GeoSolv, LLC

March 11, 1998

Response to Alameda County Health Care Services Correspondence, dated to February 9, 1998, regarding the Subsurface Investigation Report on Hydrocarbons at the Former Glovatorium/The Leather Cleaners Site Located at: 3815 BROADWAY, OAKLAND, CA 94611

FEBRUARY 1998 SCALE: 1"=20' SHEET 1 OF 1 DRAWING NO. 142005 Exhibit - B

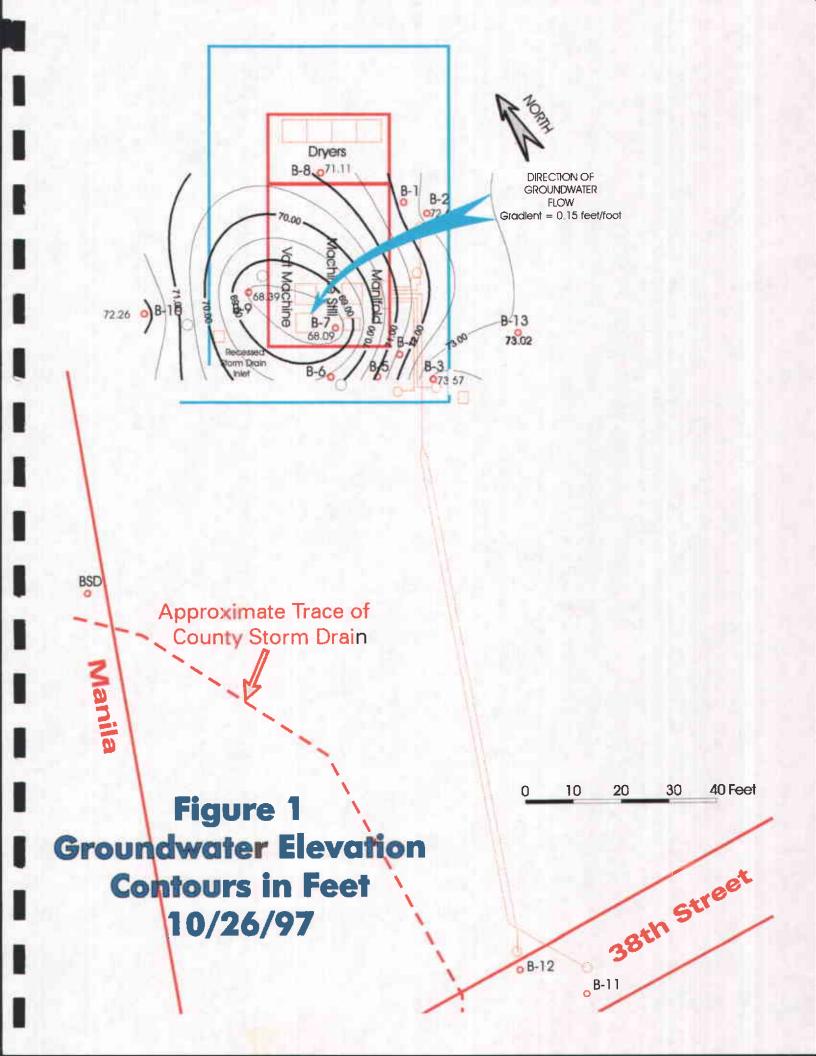
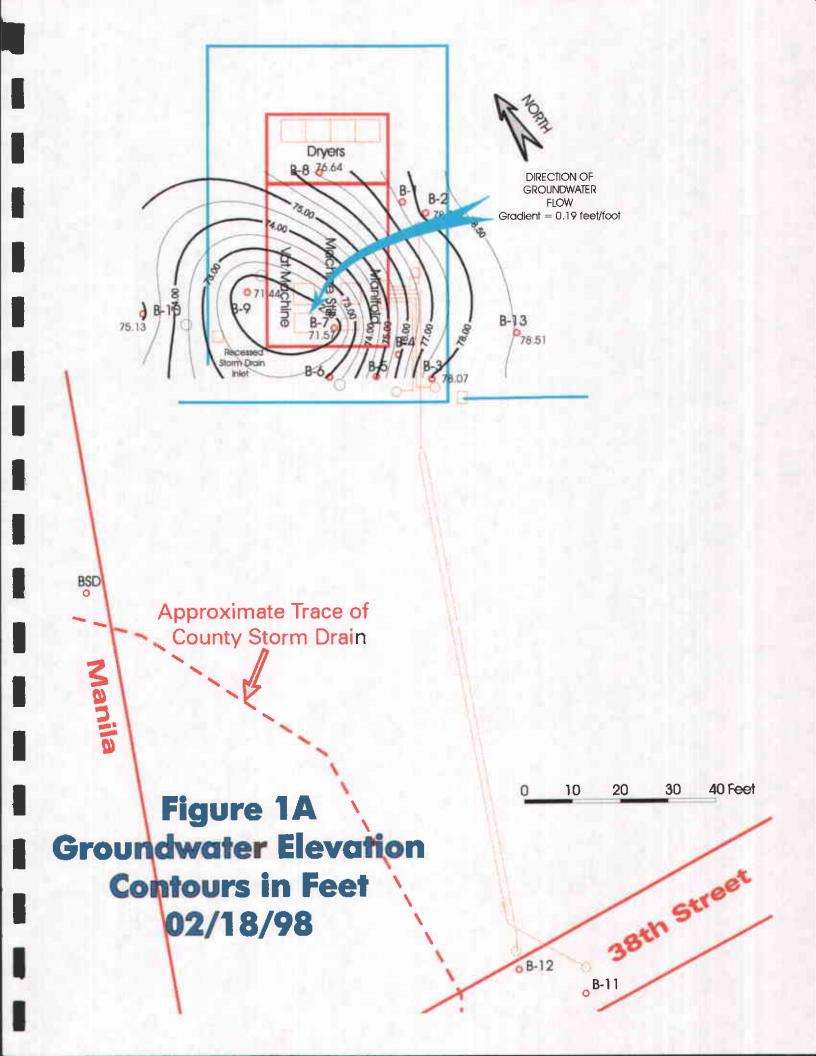
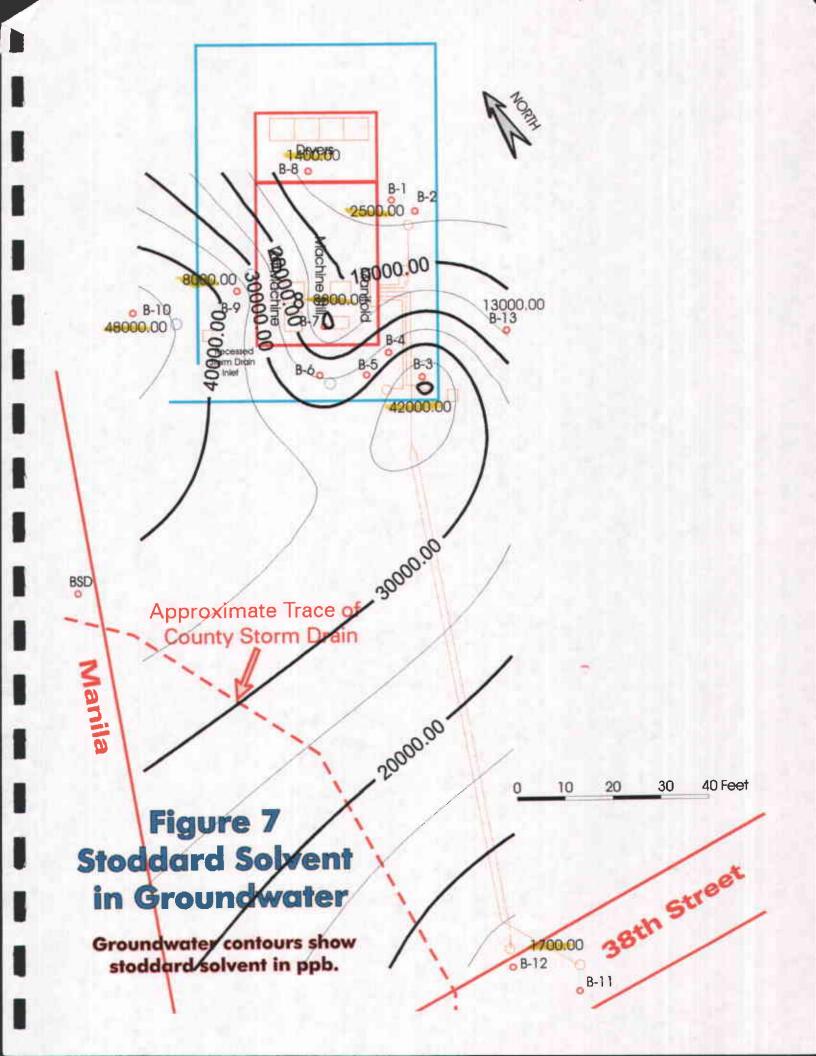
1) "Well" Survey Information

You have requested that we provide you with "well" survey information. For clarification, we note that no groundwater monitoring "wells" have yet been installed on the Property. The final workplan, as approved by you, called for the installation of boreholes in order to establish a guide for the placement of subsequent wells.

2) Relationship Between "wells" "A" through "G" and Borings B1 through B13 and BSD

In any event, enclosed is a survey of seven piezometer locations (See Exhibit A for October 1, 1997 land survey). The survey shows the location of survey the benchmarks, the locations of the piezometers and the standard reference elevation mark to which the wells were surveyed.

The seven data points labeled as A, B, C, D, E, F, and G on the survey correspond with boreholes/piezometers 13, 3, 2, 8, 10, 7, and 9.

Figure 8 Chlorinated Solvents in Groundwater 38th Street

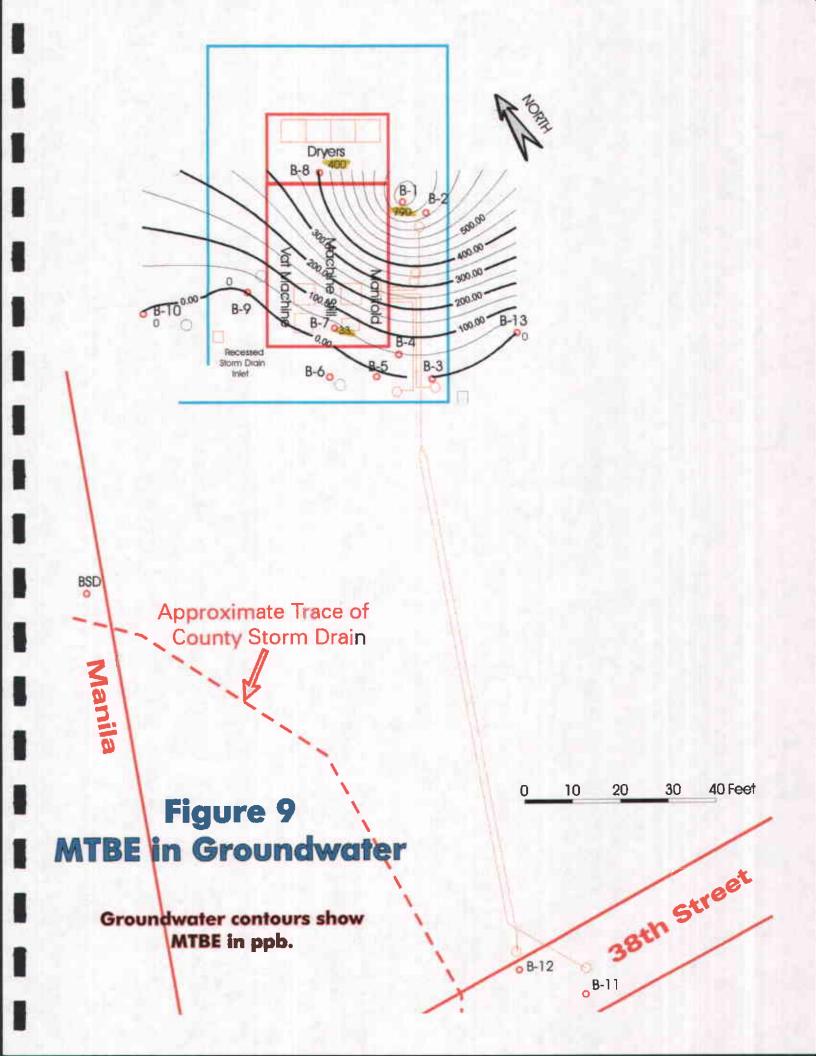
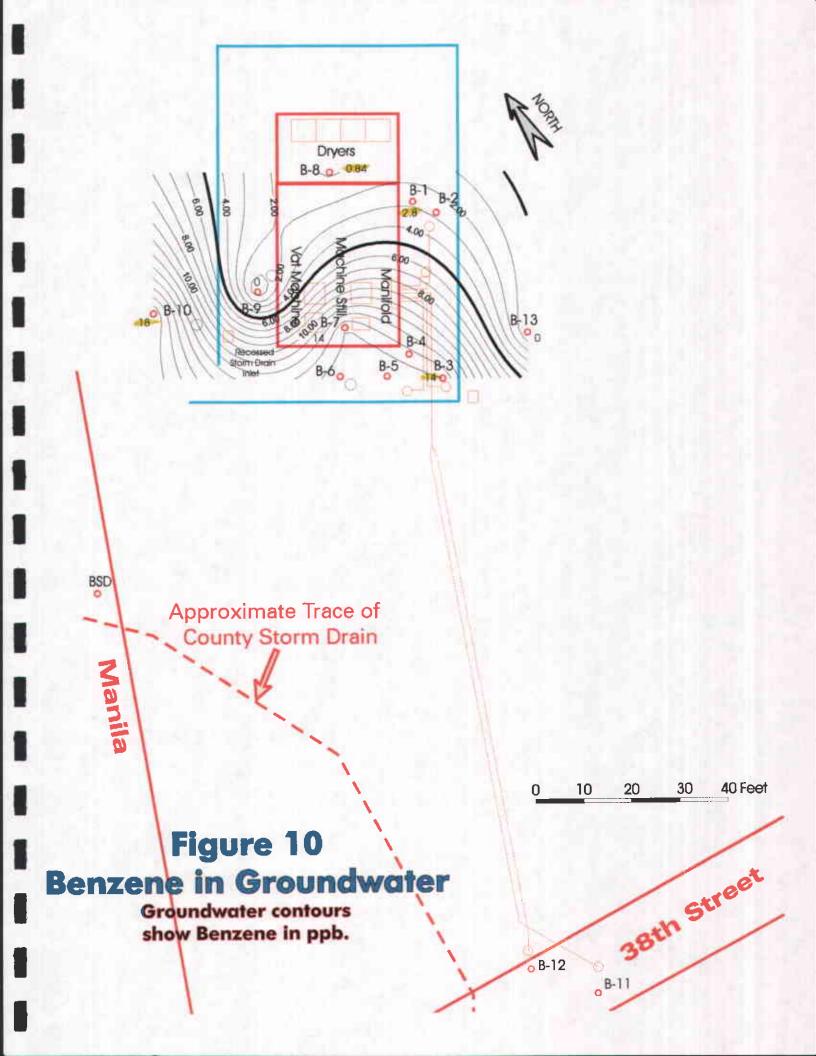
5) Map Labels

The revised map figures were produced according the certified land survey of piezometer locations (See Exhibit C for Revised Figures). One additional water level survey performed on 2-28-98 has been included as Figure 1A.
